Attachment 1 - PLN21/0569 - 69 Smith Street, Fitzroy – Advertised Section 57B - Amended plans

Project Title
**Mixed-use Redevelopment
69 Smith Street, Fitzroy, 3065 VIC**

ESD Formal Referral Response

Urban Design Formal Referral Response

Above: Sight line drawing extract from drawing no. TP301

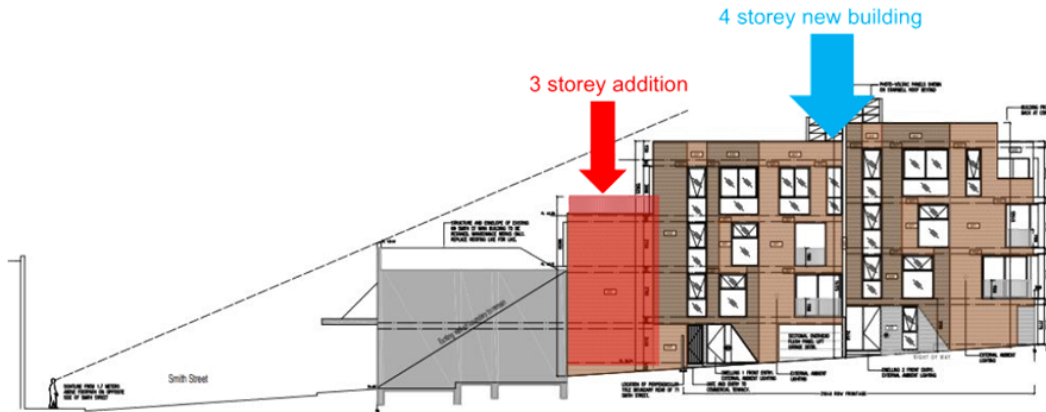
Based on the submitted sightline drawing it appears that the proposed four-storey building at the rear of the subject site will not be visible from Smith Street.

The scale of a four-storey street wall to Little Smith Street will however be at least one floor higher than the height of existing adjacent buildings in this part of the street. Setting the top floor back from the rear street frontage (west elevation) will bring the street wall height down to a similar height of other buildings in the street and therefore reduce the dramatic impact of this building, which will continue to be the highest in the area.

Above: Rear elevation of the proposed development fronting Little Smith Street

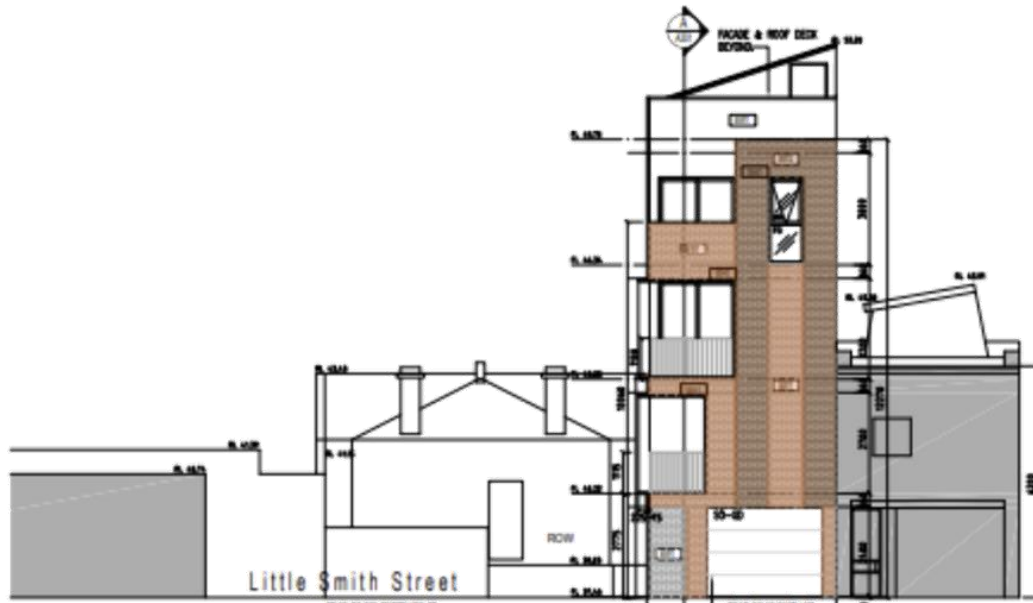
The proposed four-storey development fronting Little Smith Street will be constructed of face brick, using random pattern and coursing to provide visual interest in the facades. As there is no consistent pattern of details in the street, it is considered that the appearance of the proposed four-storey building visible from Little Smith Street is acceptable.

Officer Explanation: As proposed the rear development will result in a four-storey street wall which will be dramatically higher than the nearby existing built forms in this part of Little Smith Street

DEVELOPMENT LAYOUT DESIGN

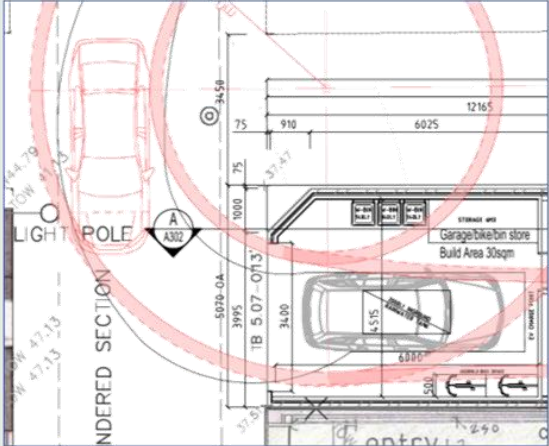
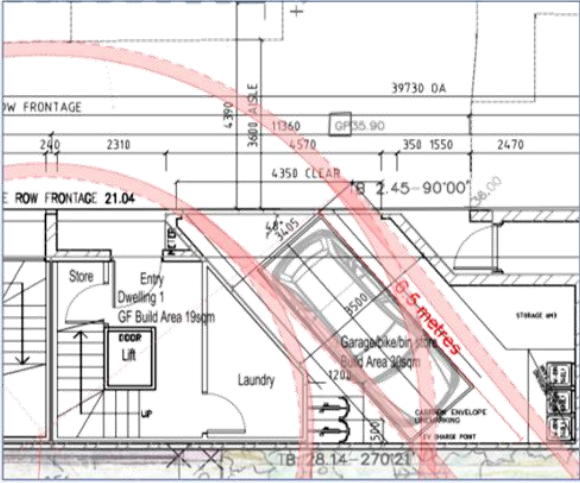
Item	Assessment
Access Arrangements	
<p>Garage Doorway – Little Smith Street Frontage</p>	<p>The single garage for dwelling 2 has a width of 3.4 metres. A check of the garage doorway using the Trapeze plan management tool indicates that a B85 design vehicle can satisfactorily enter and exit the garage via Little Smith Street, as shown below:</p>  <p>The two bicycles spaces along the south side of the garage may be impacted by a turning vehicle.</p>
<p>Garage Doorway – East-West Aligned Laneway</p>	<p>The garage doorway abutting the east-west aligned laneway has a width of 4.25 metres. A check using Trapeze indicates that a B85 design vehicle can enter and exit the garage for Dwelling 1 via the laneway, as shown below:</p>

Item	Assessment
<p>Reversing Movements out of the East-West Aligned Laneway</p>	<p>The east-west aligned laneway has a single lane carriageway width of 3.6 metres and terminates at the western boundary of 71 Smith Street, and a length of 21 metres. Vehicle volumes and speeds are minimal. Reversing movements onto Little Smith Street would be dissimilar to vehicle reversing movements out of a garage. Google Streetview images show vehicles in the east-west laneway would have entered in a forward direction and would need to exit by reversing out.</p>  <p>On that basis, there is no objection to reversing movements of this laneway onto Little Smith Street.</p>
<p>Car Parking Modules</p>	
<p>Garage for Dwelling 2</p>	<p>The garage for Dwelling 2 has a minimum envelope of 3.5 metres by 6.0 metres, which satisfies Design standard 2: Car parking spaces of Clause 52.06-9.</p>
<p>Garage for Dwelling 1</p>	<p>The garage for Dwelling 1 does not have a conventional design as it is aligned in an obtuse angle from the laneway. By using first principles, the garage has a clear width of 3.5 metres and an angled depth of the garage is 6.5 metres, which allows for car door opening on either side of the vehicle. The garage is essentially an enclosed angle parking space and can comfortably accommodate a B85 design vehicle (1.87 metres by 4.91 metres). The design of garage is considered satisfactory for this development.</p>

Finished Floor Level at Edge of Slab	The front edge of the garage slab at the property line is to be set 40 mm higher than the edge of the bluestone laneway. This 40 mm lip* is to be depicted on a section drawing. The reduced level of the south edge of the laneway at the garage entrance is to be shown on the section drawing.

Item	Details
Garage for Dwelling 2	The applicant should consider providing wall mounts for the two bicycle spaces along the southern wall of the garage so as to not obstruct a vehicle as it enters the garage from Little Smith Street.
Vehicle Crossing Ground Clearance	<p>To assist the applicant, a <i>Vehicle Crossing Information Sheet</i> has been appended to this memo. The ground clearance check requires the applicant to obtain a number of spot levels which include the reduced level 2.0 metres inside the property, the property boundary level, the bottom of kerb (invert) level, the edge of the channel level and a few levels on the road pavement – in this case, Little Smith Street.</p> <p>These levels are to be shown on cross sectional drawings with dimensions, together with the B85 design vehicle ground clearance template demonstrating access and exit movements.</p>
